## PCI-SIG ENGINEERING CHANGE NOTICE

| <b>TITLE:</b>             | PCI Express Capability Structure Expansion  |
| <b>AFFECTED DOCUMENT:</b> | PCI Express Base Specification Revision 1.1 |

**Figure 7-9: PCI Express Capability Structure**

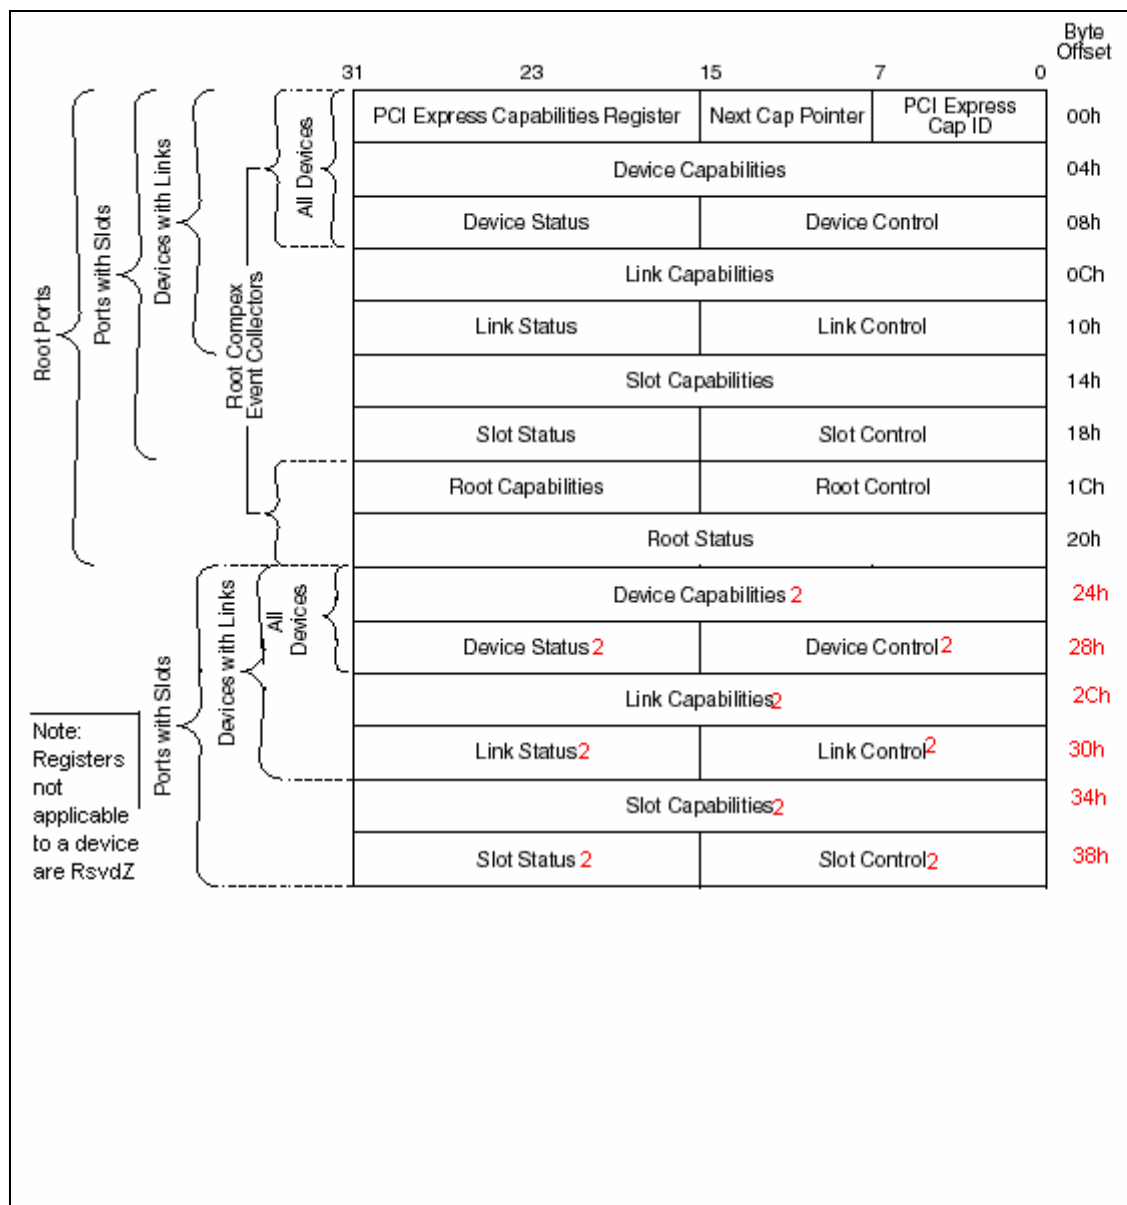
Figure 7-9 details allocation of register fields in the PCI Express Capability structure.

The PCI Express Capabilities, Device Capabilities, ~~and Device Status~~ and ~~/Control~~ registers are required for all PCI Express devices. Device Capabilities 2, Status 2 and Control 2 registers are required for all PCI Express devices that implement capabilities requiring those registers. For devices that do not implement the Device Capabilities 2, Status 2, and Control 2 registers, these spaces must be hardwired to 0.

The Link Capabilities, ~~and Link Status~~ and ~~/Control~~ registers are required for all Root Ports, Switch Ports, Bridges, and Endpoints that are not Root Complex Integrated Endpoints. For devices that do not implement the Link Capabilities, Status and Control registers, these spaces must be hardwired to 0. Link Capabilities 2, Status 2 and Control 2 registers are required for all Root Ports, Switch Ports, Bridges, and Endpoints (except for Root Complex Integrated Endpoints) that implement capabilities requiring those registers. For devices that do not implement the Link Capabilities 2, Status 2 and Control 2 registers, these spaces must be hardwired to 0. ~~Endpoints are not required to implement registers other than those listed above and terminate the capability structure.~~

Slot Capabilities, Status and Control registers are required for Switch Downstream and Root Ports if a slot is implemented on the Port (indicated by the Slot Implemented bit in the PCI Express Capabilities Register). For devices that do not implement the Slot Capabilities, Status and Control registers, these spaces must be hardwired to 0. Slot Capabilities 2, Status 2 and Control 2 registers are required for Switch Downstream and Root Ports if a slot is implemented on the Port and the device implements capabilities requiring those registers. For devices that do not implement the Slot Capabilities 2, Status 2, and Control 2 registers, these spaces must be hardwired to 0.

Root Ports and Root Complex Event Collectors must implement the Root Capabilities, Status and ~~/Status~~ Control registers. In addition to PCI Express Capabilities, Device Capabilities and Device Status/Control registers ~~For devices that do not implement the Root Capabilities, Status and Control registers, these spaces must be hardwired to 0.~~

~~Root Control/Status registers are required for Root Ports. Root Ports must implement the entire PCI Express Capability structure. Slot Capabilities and Slot Status/Control registers are required for Switch Downstream and Root Ports if a slot is implemented on the Port~~
